**WOODBIDGE SCHOOL DISTRICT
New Woodbridge High School
Bid Pac A**

ADDENDUM NO.4

27 July 2012

ARCHITECT'S PROJECT NO: 11109

1
S-5K-05

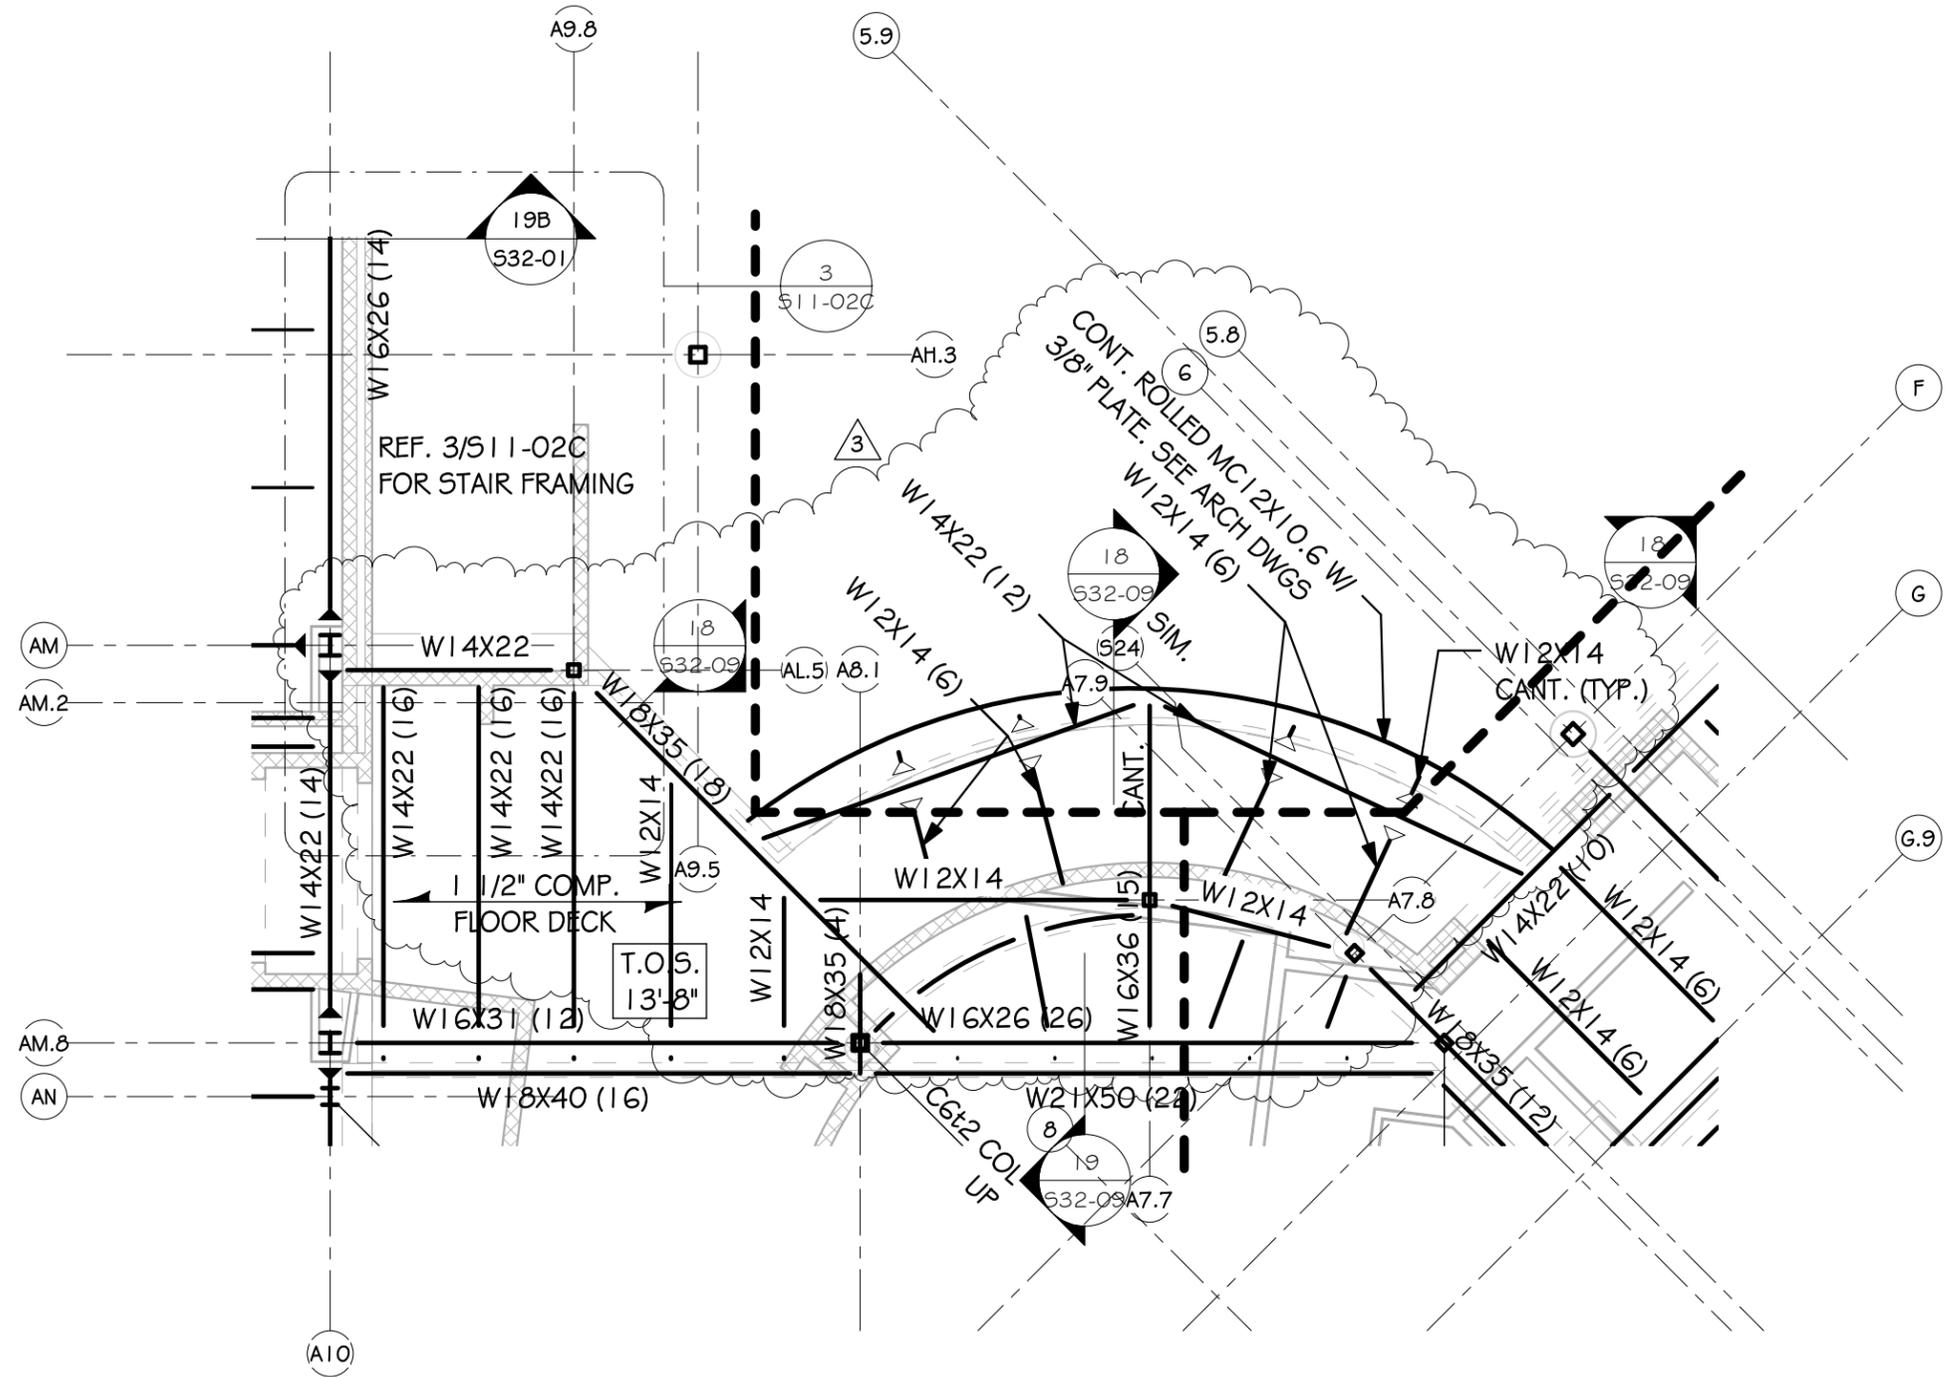
- a. INSERT attached sketches S-SK-4, S-SK-5, S-SK-6, S-SK-7, S-SK-9, S-SK-12, and S-SK-13. These sketches were originally issued in Addendum 3 and have been cleaned up to clearly show section cuts.
- b. INSERT attached sketch S-SK-22. This sketch was originally issued in Addendum 3. The previous dimension has been revised to read "REF ARCH"

1
S-SK-28

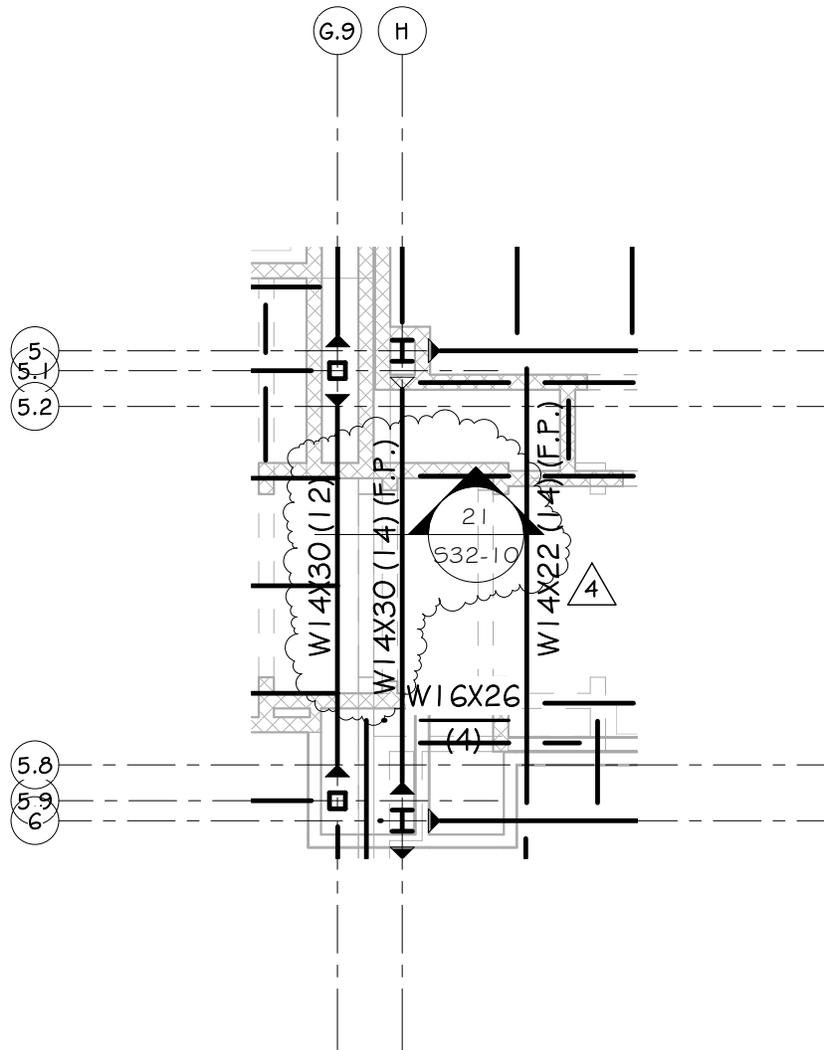
4.9 ADD attached sketches S-SK-28 thru S-SK-32 for additional modifications.

DRAWING TITLE: PARTIAL SECOND FLOOR PLAN - AREA D - POWER	
OWN BY: CLJ	PROJ. NUMBER: 11156
CHK BY: CDH	DRAWING NUMBER: EP11-02D
DATE: 07-26-12	SCALE: 1/8" = 1'-0"

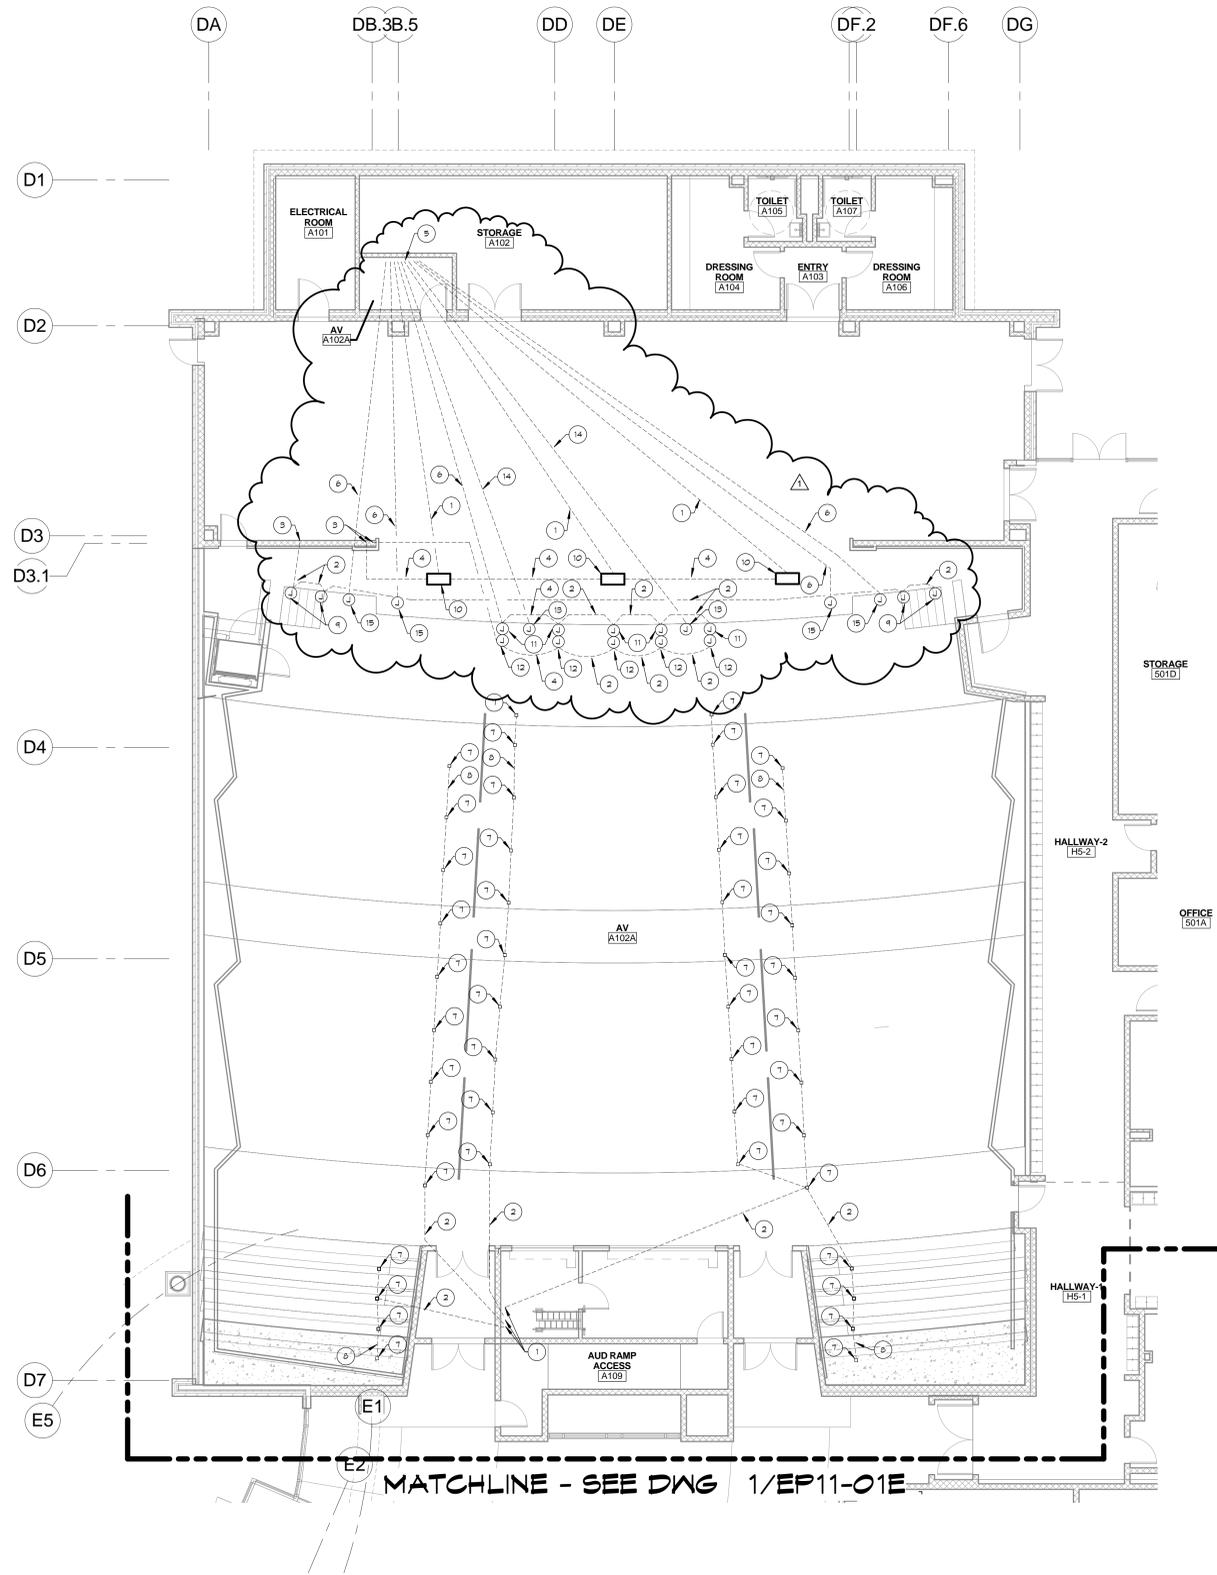
2.7 **Q:** Drawing EP11-02D, Science lab "402-2 and 406," shows no floor boxes, where and how are we to terminate the conduits? Please advise.

2.16 **Q:** On drawing EP11-02D, the two science labs show conduit in the slab and the runs just stop in the middle of the floor. Are these runs supposed to turn up out of the slab or go to a floor box? Please inform me on how to proceed with these conduits.

A: Drawing EP11-02D is to be replaced in its entirety. See attached PDF.

A: Drawing EP11-02D is to be replaced in its entirety. See attached PDF.

1 PARTIAL SECOND FLOOR PLAN - AREA D - POWER
1/8" = 1'-0"
SCALE: 1/8" = 1'-0"

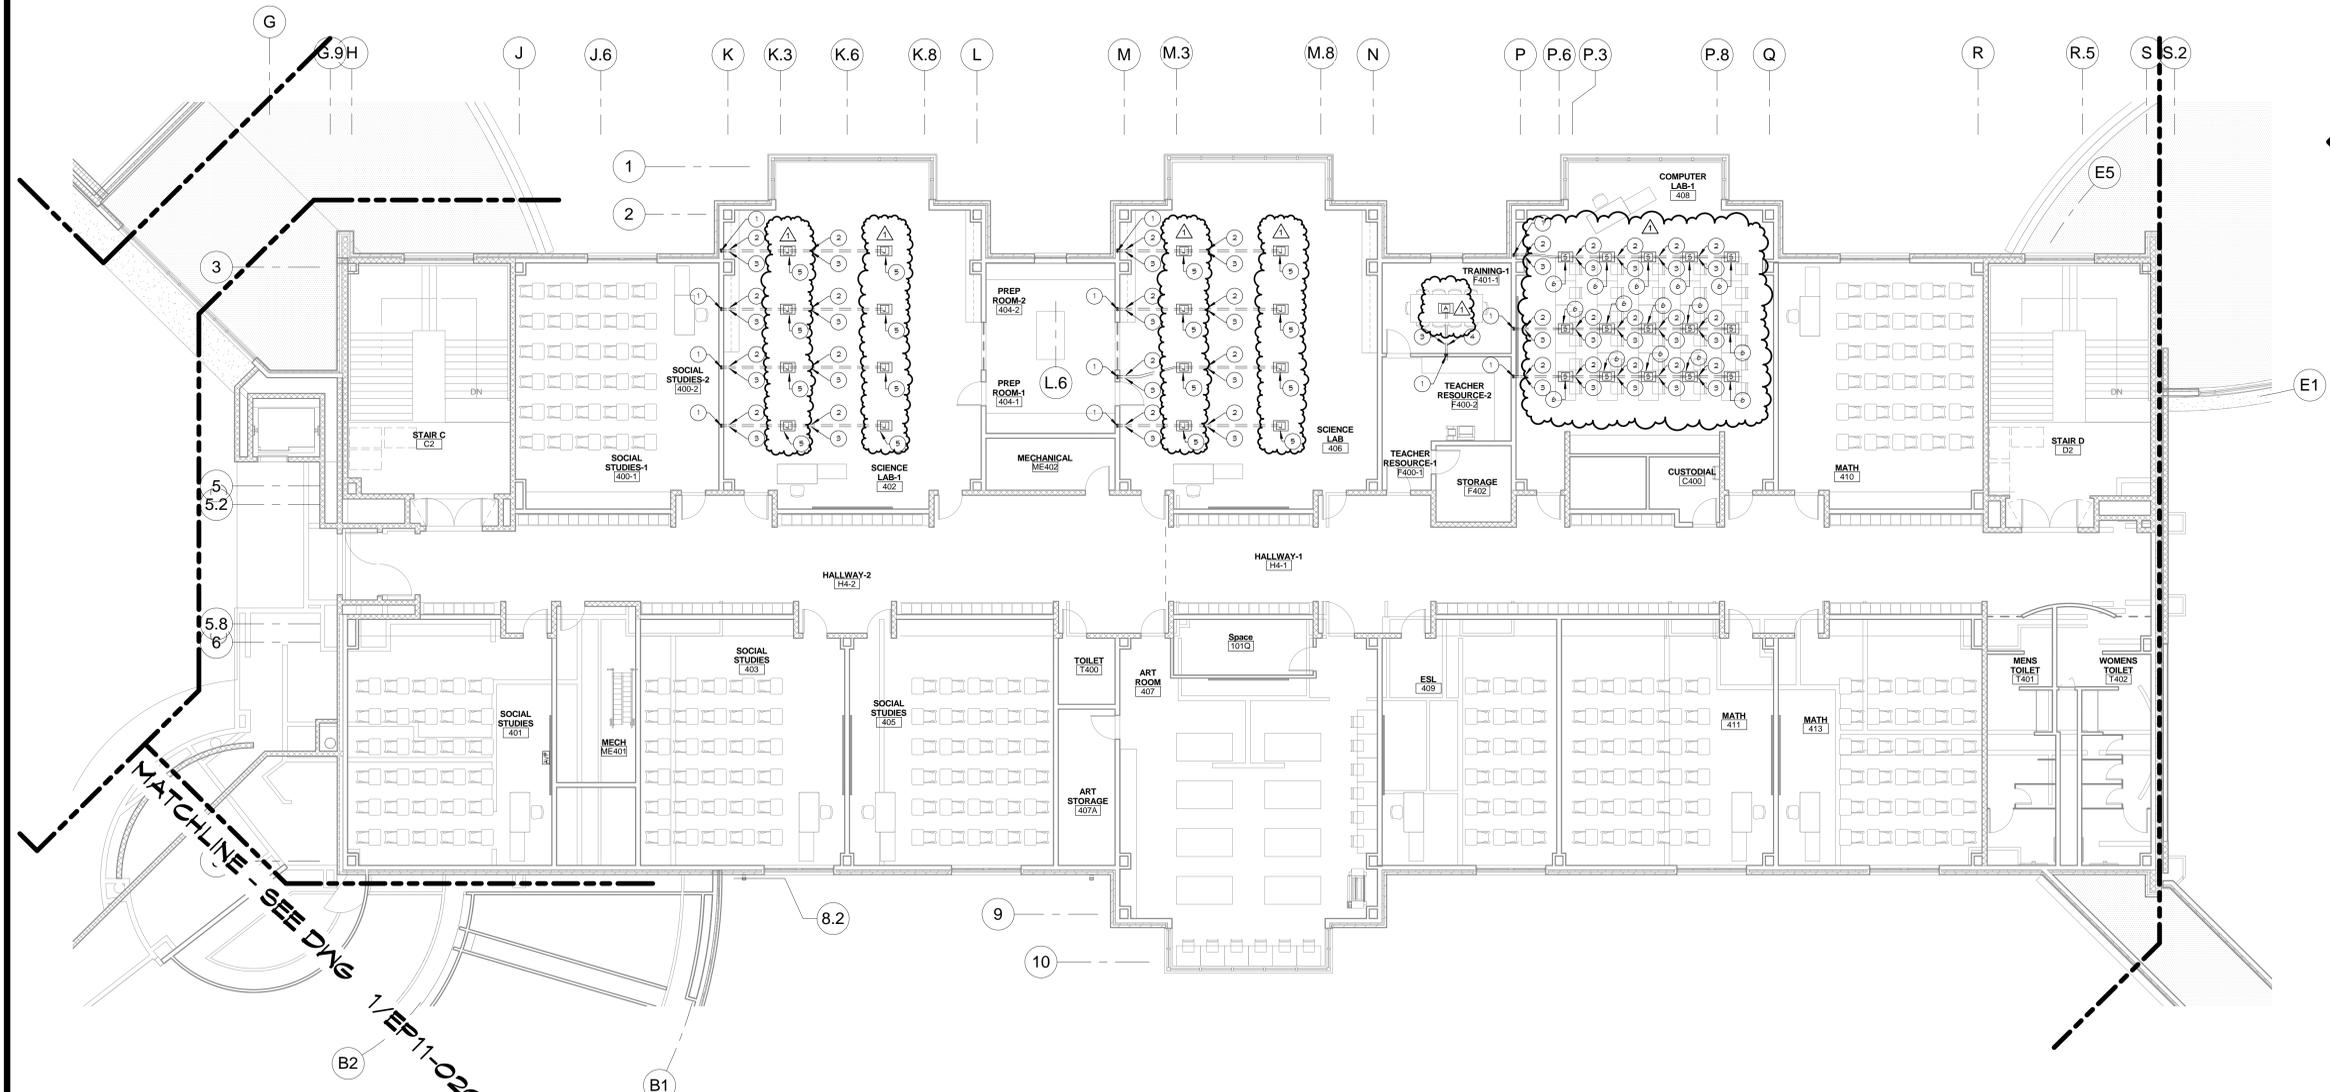
▲ ADD FLOOR BOXES TO SCIENCE LAB ROOMS 402 AND 406.

DWN BY: CLJ	CHK BY: CDH	PROJ. NUMBER: 11156
DATE: 07-26-12	DRAWING NUMBER: EP-13.01	
SCALE: AS NOTED

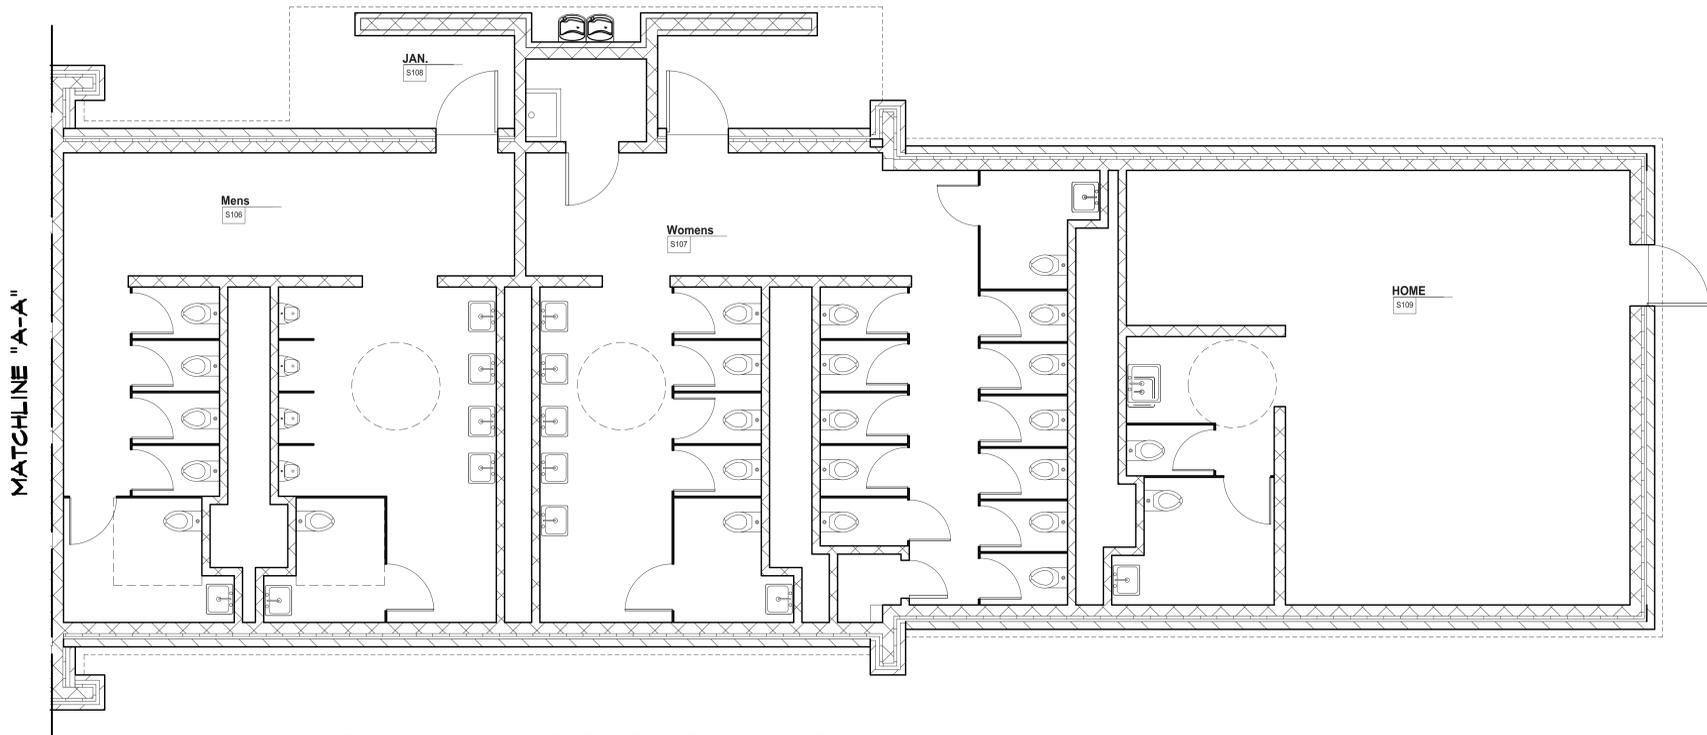
4.11 ADD drawing EP-13.01/
